SERVICE BULLETIN MAINTENANCE OF WAY EQUIPMENT

DATE: 4-14-2003 **BULLETIN NO:** 03-005

TITLE: 200685 SLC 503 CPU OPERATING SYSTEM AND MEMORY UPGRADE KIT
200714 SLC 500 DTAM FIRMWARE UPGRADE KIT

PRODUCT SERIES / MODEL: W96 Series E and F Spike Drivers
RMC306 Series C Anchor Boxers

FIGURE 2
SLC 500 DTAM MODULE - REAR VIEW

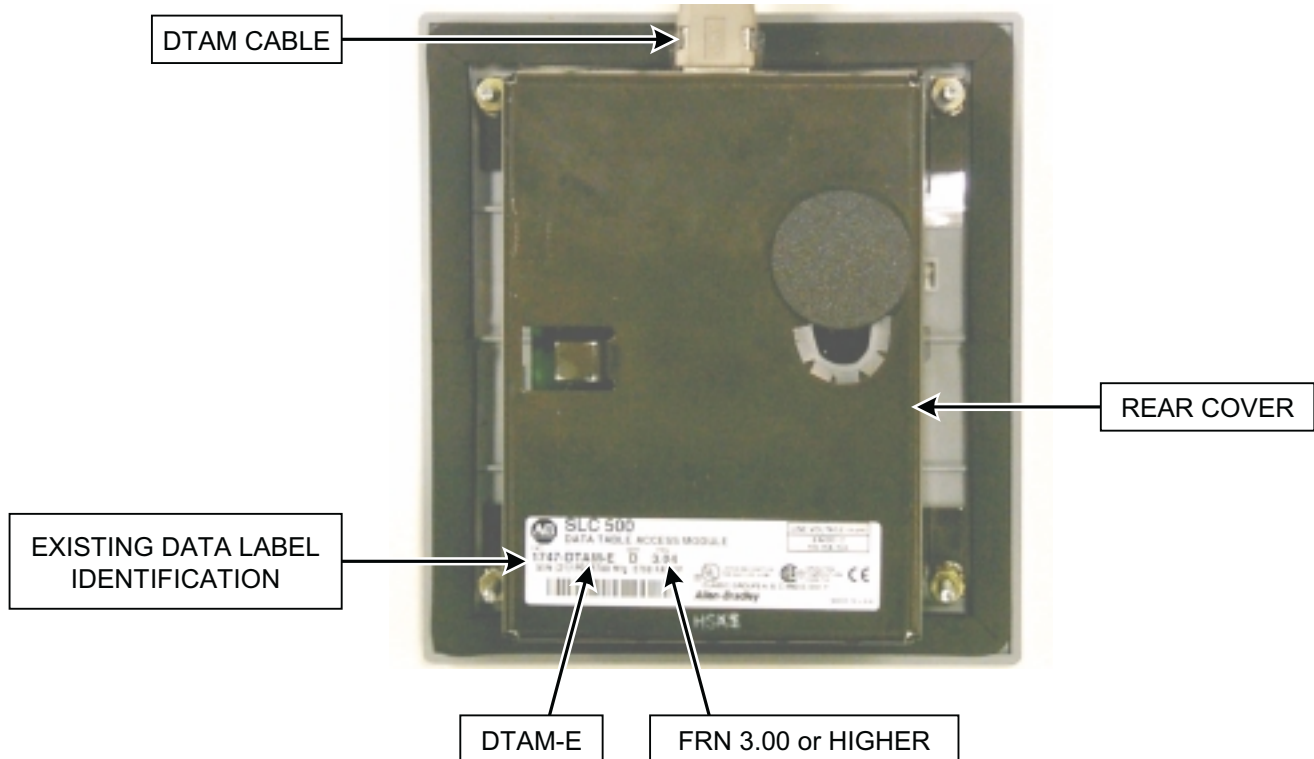
IDENTIFYING EXISTING DTAM FIRMWARE - See Figure 1 and Figure 2

4. Remove all power from machine.
5. Locate DTAM Module in Control Box on machine.
6. Remove screws and swing face panel of Control Box out to view rear of DTAM Module.
7. Look at data identification label on rear of DTAM Module. The DTAM Module is identified as DTAM or DTAM-E and the firmware is identified as FRN 0.00.
 - 7.1 If data identification label is DTAM-E and FRN 3.00 or higher, this DTAM Module will support new M13 Memory Module # 200684. Go to Step 8.
 - 7.2 If data identification label is DTAM and/or FRN 2.99 or lower, this DTAM Module requires DTAM Firmware Upgrade Kit # 200714 to support new M13 Memory Module # 200684. Go to Step 10 to install DTAM Firmware Upgrade.
8. Swing face panel of Control Box in and re-secure with screws.
9. Go to Step 24 to verify existing Operating System.

FIGURE 3
SLC 500 DTAM MODULE - REAR VIEW

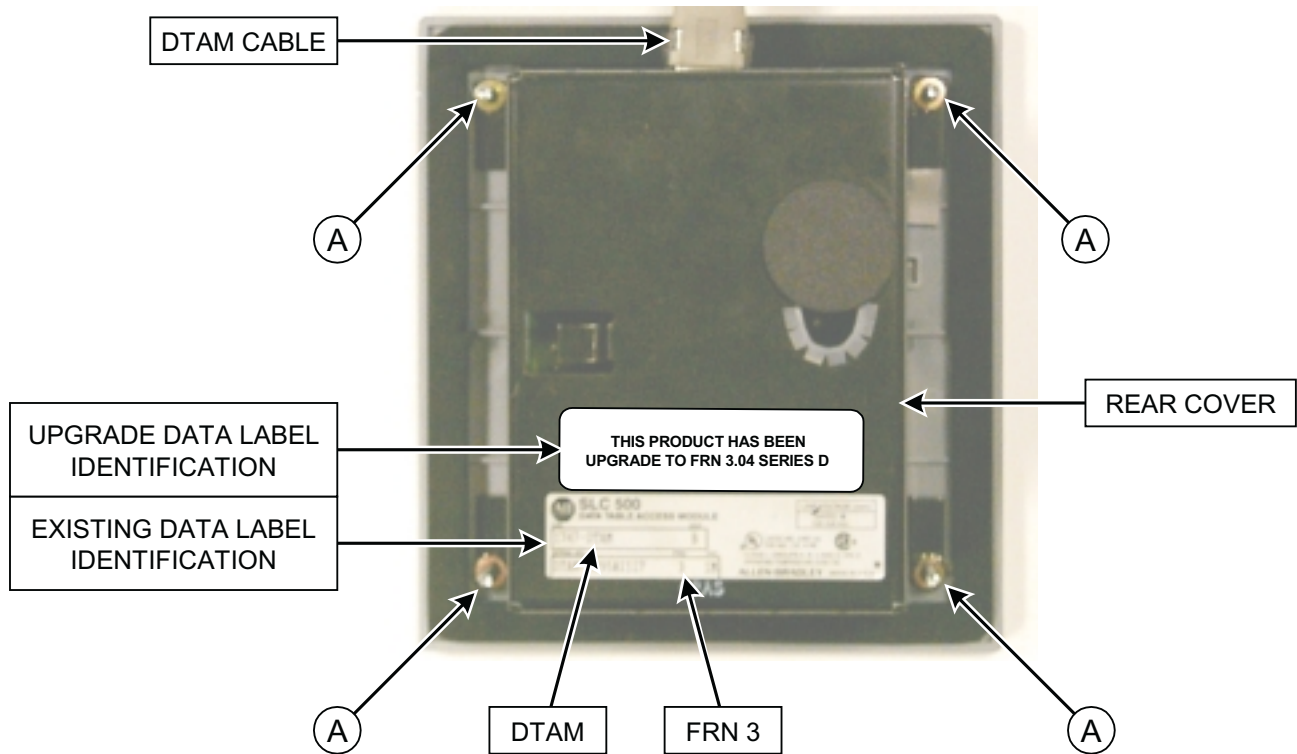
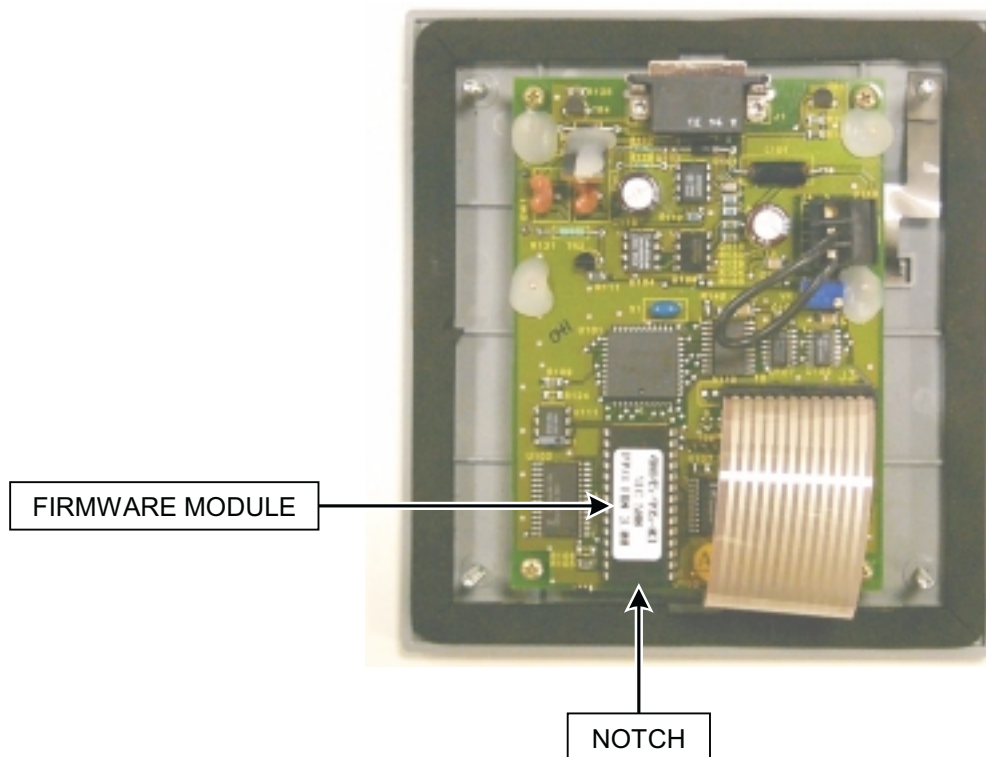
INSTALLING NEW DTAM FIRMWARE - See Figure 3 and Figure 4

- 10. Disconnect DTAM Cable from DTAM Module by depressing lock tab and pulling Cable straight out.
- 11. Remove four outer nuts (A) to remove DTAM Module from face panel of Control Box.
- 12. Remove four inner nuts (A) to remove cover from rear of DTAM Module.
- 13. Remove existing Firmware Module from socket on DTAM Module.
- 14. Remove Upgrade Firmware Module # FOR007528 from shipping package. Install Upgrade Firmware Module in socket on DTAM Module.

Note: Align module with socket so notch is towards bottom of DTAM Module.

- 15. Re-install cover on rear of DTAM Module and secure re-using four nuts (A).
- 16. Install new firmware FRN 3.04 data identification label on rear of DTAM Module.
- 17. Re-install DTAM Module in face panel of Control Box and secure reusing four nuts (A).
- 18. Install DTAM Cable in socket of DTAM Module by aligning lock tab with notch and pushing in gently until lock tab clicks.
- 19. Swing face panel of Control Box in and re-secure with screws.
- 20. Restore power to machine.
- 21. Turn on (boot-up) PLC.
- 22. PLC should boot up normally and "ENTER DISPLAY #" screen should be displayed on DTAM Module as illustrated to right.

FIGURE 5
SLC 503 CPU MODULE - FRONT VIEW

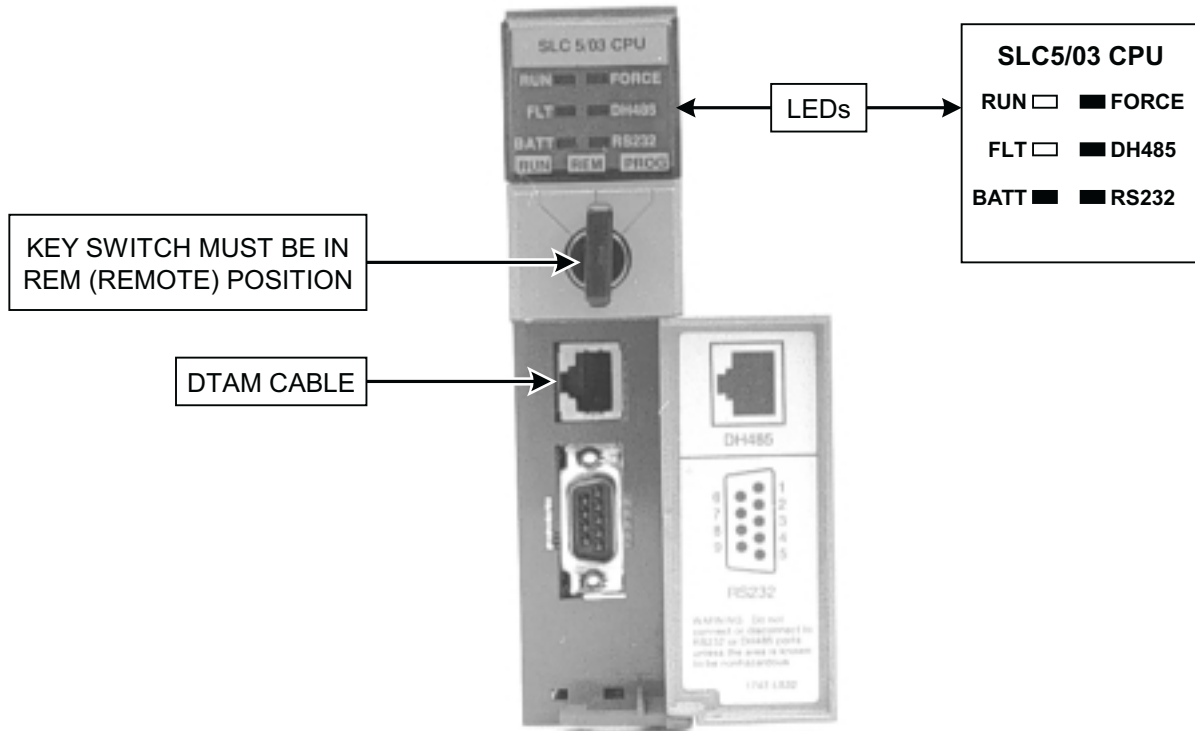
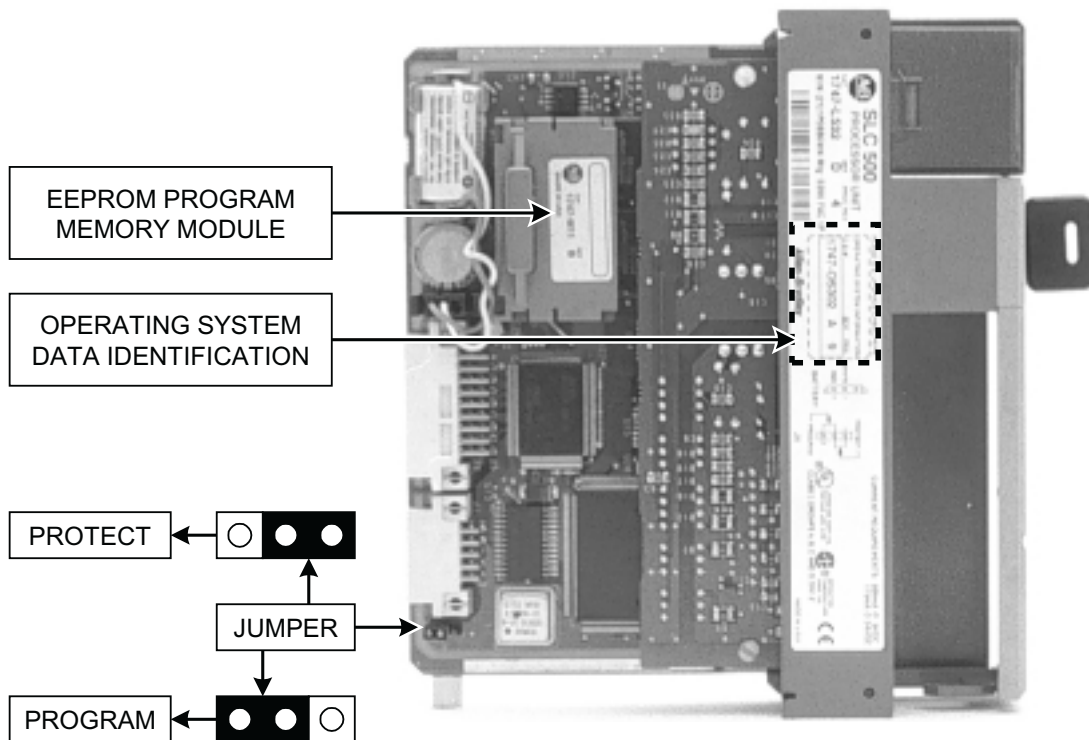
INSTALLING NEW CPU OPERATING SYSTEM OS302C - See Figure 5 and Figure 6

30. Remove existing M11 Memory Module # F026079 from socket on CPU Module.
31. **Important:** Move jumper from "PROTECT" to "PROGRAM" on CPU Module.
32. Remove Upgrade Module # FOR007526 from shipping package. Install Upgrade Module in socket on CPU Module.

37. After Operating System has been successfully upgraded in approximately 2-1/2 minutes, four LEDs (RS232 - DH485 - FORCE - BATT) on front of CPU Module will remain On steady as shown in Figure 5.

Note: Upgrade Module # FOR007526 can be returned to HTT at Fairmont, MN. Facility for credit, if so desired.
40. Install new Operating System OS302C data identification label on CPU Module.
41. **Important:** Move jumper from "PROGRAM" to "PROTECT" on CPU Module.
42. Install existing M11 Memory Module # F026079 (with existing program) or new M13 Memory Module # 200684 (with new program) in socket on CPU Module.

FIGURE 8
LOADING PROGRAM INSTRUCTIONS

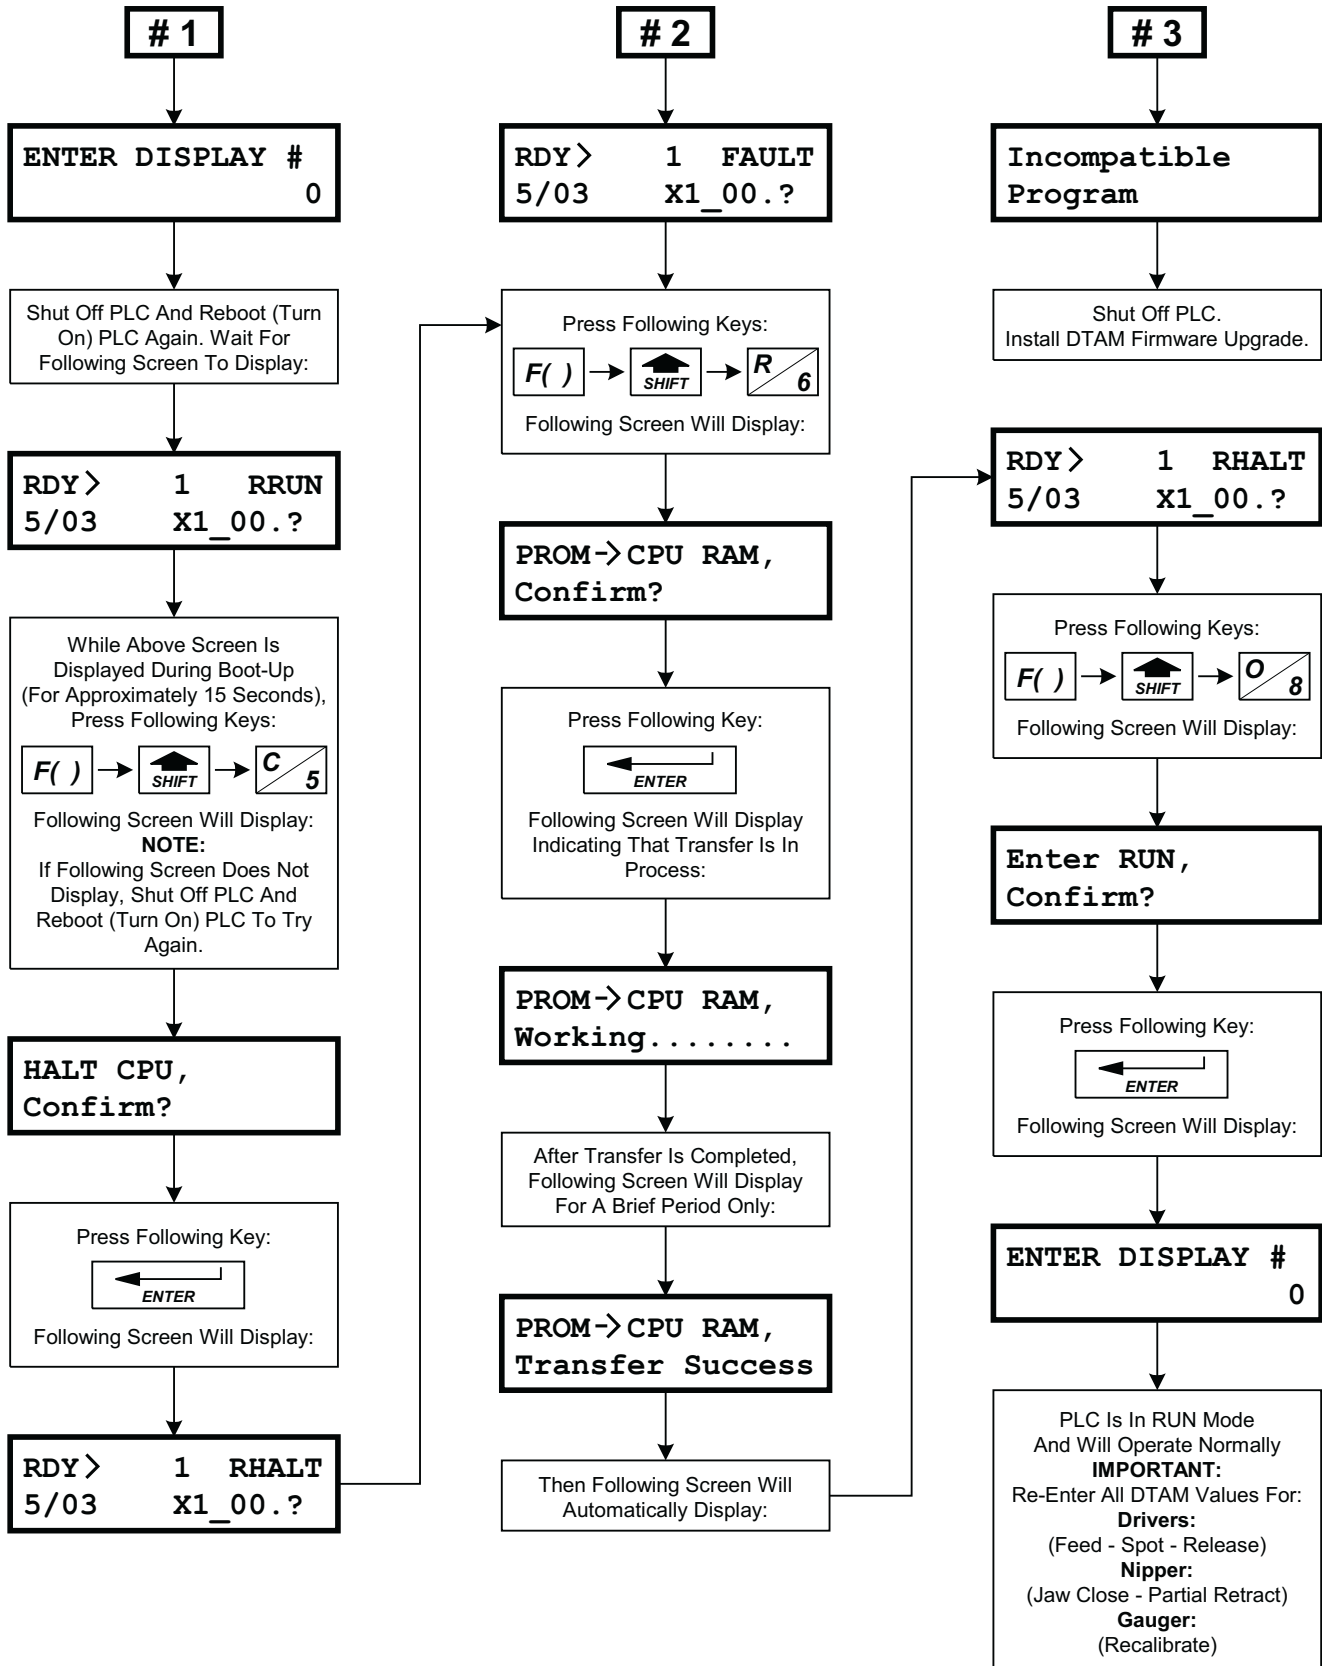
LOADING PROGRAM - See Figure 1 and Figure 8

- 47. Restore power to machine.
- 48. Turn on (boot-up) PLC.
- 49. After PLC boots up, note screen displayed on DTAM Module . DTAM Module should display one of following screens illustrated in Figure 8.
 - #1 "ENTER DISPLAY #" Screen
 - #2 "RDY 1 FAULT" Screen
 - #3 "Incompatible Program" Screen

Note: If any other screen is displayed on DTAM Module after boot-up other than screens illustrated, consult factory for assistance.
- 50. See Figure 8 - Loading Program Instructions for appropriate screen #1 or #2 displayed to load program.
- 51. After loading program, be sure to record program number in spaces provided in Figure 7 of this Service Bulletin for future reference.
- 52. **Important:** Re-enter all recorded DTAM values for following:
 - 52.1 W96E / F Spike Drivers
 - a. Drivers: Feed - Spot - Release
 - b. Nipper: Jaw Close - Partial Retract
 - c. Gauger: Must Be Re-Calibrated
 - 52.2 RMC306C Anchor Boxers
 - a. Work-head: Swing Out - Swing In - Feed
 - b. Work-head: Down - Spot - Up
 - c. Timers: Pre-Squeeze - Head Release - Feed - Clamp
